NEWMAR CORP P.O. Box 30, Nappanee, IN. 46550 UNITS: INCHES TITLE BLOCK: 75TB	Model:	Sheet	Drawn by:	Checked by:	Revision:	By:
	BT CA	2 OF 3	R. W.	J. S.	Adjusted front CNC piece to match cab frame better (ECO #391)	R. W.
	Title:	I.D. # 2017\CA\SIDEWALL\BT\BTCA_CAB_FRAME	Date:	Date:	Revision:	By:
	WINDOW TRIM		9/21/16	9/22/16	NEW 2017 PRINT; CREATED 5/8" X 1 3/8" WOOD BACKER AROUND ODS AND PS COCKPIT WINDOWS	R. W.
					ILO 5/8" BEAD FOAM TO REDUCE CAB NOISE OVER TIME; THIS ELIMINATES FOAM SEAL FROM ECO #385 (ECO #391)	Date: 9/21/16

NEWMAR CORP P.O. Box 30, Nappanee, IN. 46550 UNITS: INCHES TITLE BLOCK: 75TB	Model:	Sheet	Drawn by:	Checked by:	Revision: NEW 2017 PRINT; CREATED 5/8" X 1 3/8" WOOD BACKER AROUND ODS AND PS COCKPIT WINDOWS	By: R. W.
	BT CA	3 OF 3	R. W.	J. S.	ILO 5/8" BEAD FOAM TO REDUCE CAB NOISE OVER TIME; THIS ELIMINATES FOAM SEAL FROM ECO #385 (ECO #391)	Date: 9/21/16
	Title: REAR SIDEWALL DETAIL	I.D. # 2017\CA\SIDEWALL\BT\BTCA_CAB_FRAME	Date:	Date:	Revision:	By:
			9/21/16	9/22/16		Date:

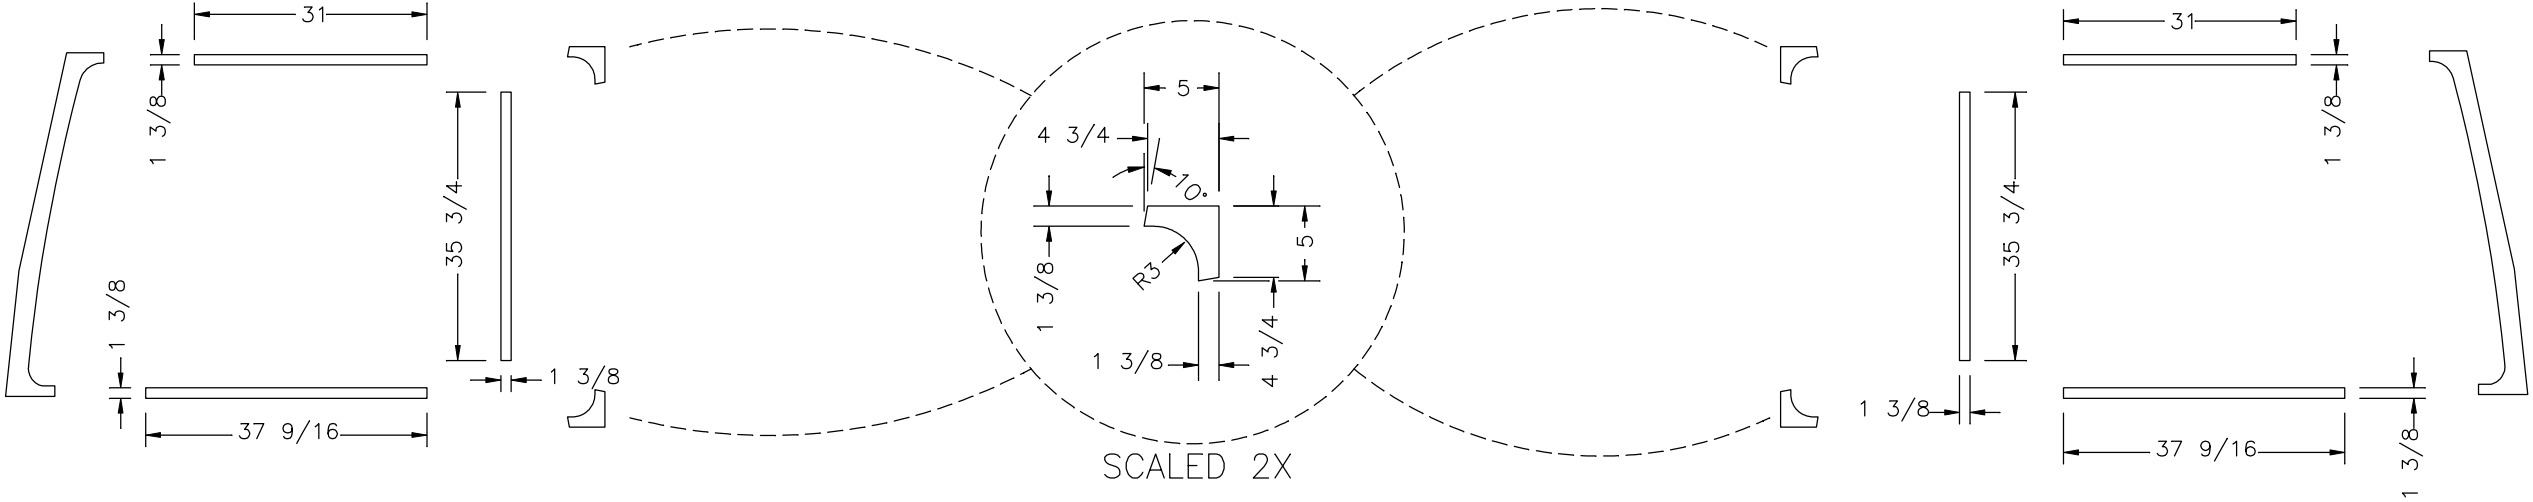
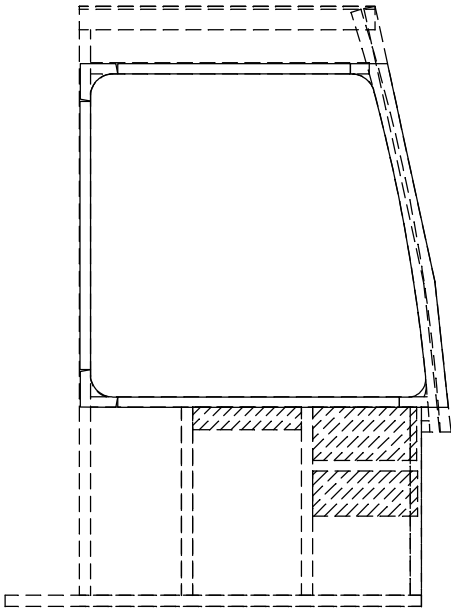
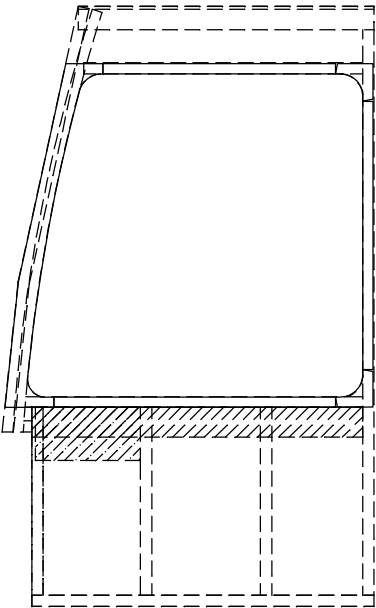
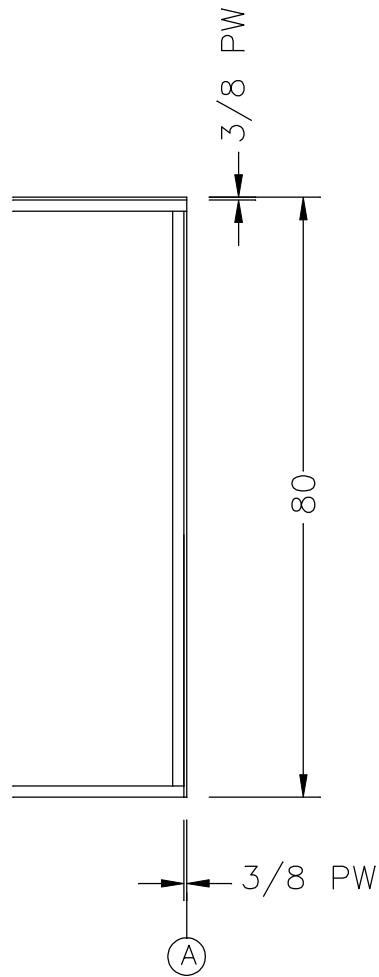
5/8 X 1 3/8
PLYWOOD TO REPLACE
5/8 BEAD FOAM
AROUND WINDOWS
